## Comment Letter NRDC

<b>NRDC</b>
		<small>NATURAL RESOURCES DEFENSE COUNCIL</small>
February 7, 2006		
Mr. Paul Marshall SDIP EIS/EIR Comments State of California Department of Water Resources, Bay-Delta Office 1416 Ninth Street Sacramento, CA 95814		
Ms. Sharon McHale U.S. Bureau of Reclamation, Mid-Pacific Region Draft EIS/EIR Comments 2800 Cottage Way Sacramento, CA 95825		
<b>Re: Comments Regarding the South Delta Improvements Program DEIS/DEIR</b>		
Dear Mr. Marshall and Ms. McHale,		
On behalf of the 130,000 California members of the Natural Resources Defense Council, we offer the following comments regarding the SDIP DEIS/DEIR. NRDC believes that this document does not meet the requirements of CEQA and NEPA. In addition, the approach adopted by DWR and the Bureau regarding this project represents a major departure from the collaborative, open, science-based and balanced approach advocated by the CALFED Bay-Delta Program. A failure to address the fundamental flaws in this document would damage the credibility of DWR, the Bureau and CALFED. Given the precarious status of many of the estuary's fisheries, we urge the agencies to modify both the substance of the proposed proje

Figure B-1 SWP Delta Table A delivery probability for studies 1, 2 and 3

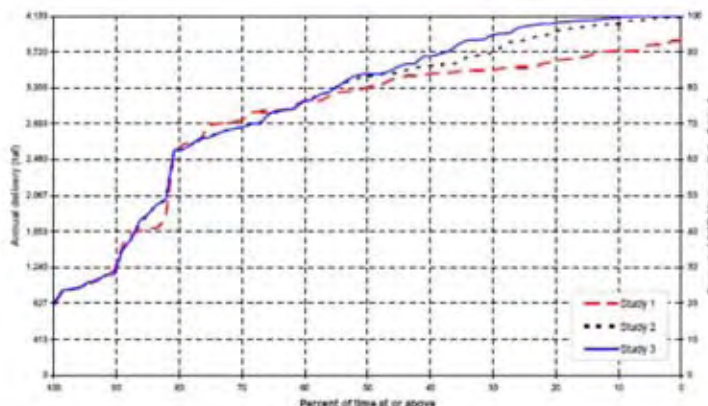
The DEIS/R should analyze this problem, for it could undermine the utility of the proposed changes. That analysis, however, is not present.

As explained above, the draft Reliability Report issued by DWR in November 2005 estimated that the reliability of water deliveries from the SWP decreases as quantity of deliveries increases. Reliability of 1.2 maf in deliveries, for instance is 90 percent, while reliability falls to around just 50 percent when project deliveries reach 3.3 maf (see figure from Reliability Report above).

**Figure 4-2 Net changes statewide in average-year water demand for baseline scenarios, 2000-2030**

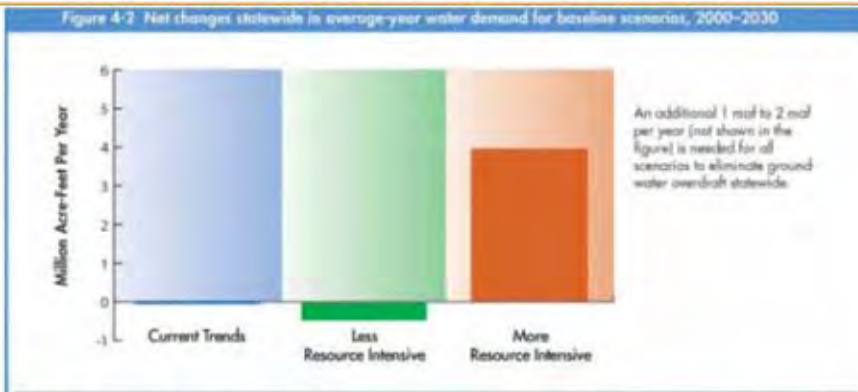
The figures included below were taken from the California Water Plan Update documents. The first figure presents data indicating that the net South of Delta demands could decrease in both the Current Trends Continued and the Less Resources Insensitive scenarios. The second figure reports the estimated net statewide demand changes under all three scenarios. The second figure indicates that statewide, demands will decrease in both the Current Trends Continued and the Less Resources Intensive scenarios.<sup>2</sup>

These studies indicate that, despite the DEIS/R assertion that there are unmet needs south of the Delta, increased exports from the Bay Delta Estuary are unnecessary. In fact, the water demand data from DWR's Water Plan Update 2005 and the Pacific Institute report demonstrates that exports from the Bay Delta Estuary could actually decrease to match decreased demands.

**Figure 8. Exceedance probability plot of SWP Annual Deliveries under climate change scenarios PCM B1-A1 and HadCM3 B1-A1 for 2070-2099**

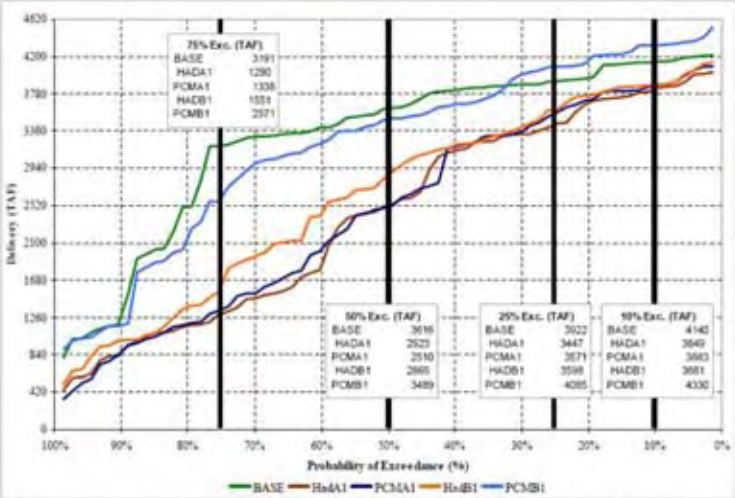
Despite the commitments made in the 2002 Reliability Report, the information above is not included in the recent draft of the 2005 Delivery Reliability Report. Nor is it included in the current SDIP DEIS/R.
